**From:** Planning  
**Subject:** FW: Planning committee meeting this week - site visit at York Ave, Portstewart  
**Attachments:** Planning Speaking Rights York Ave.docx

Planning Ref: LA01/2025/0631/F

**The application is not compliant with Policy QD1 of PPS7 or Policy AMP 7 of PPS 3 in relation to adequate parking provision.**

The house width is less than half of the adjacent properties at No.5 and No.9

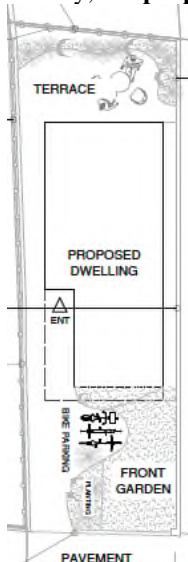
House 10.6M wide  
Plot 12.5M wide

House 4.4M wide  
Plot 5.8M wide

House 9.5M wide (set back)  
Plot 12M wide

The proposed plans show that the building would be positioned just 600mm from the boundary of No.9 and 800mm from the boundary of No. 5. This is extremely constrained and we would question the feasibility, practicality and buildability of the proposal.
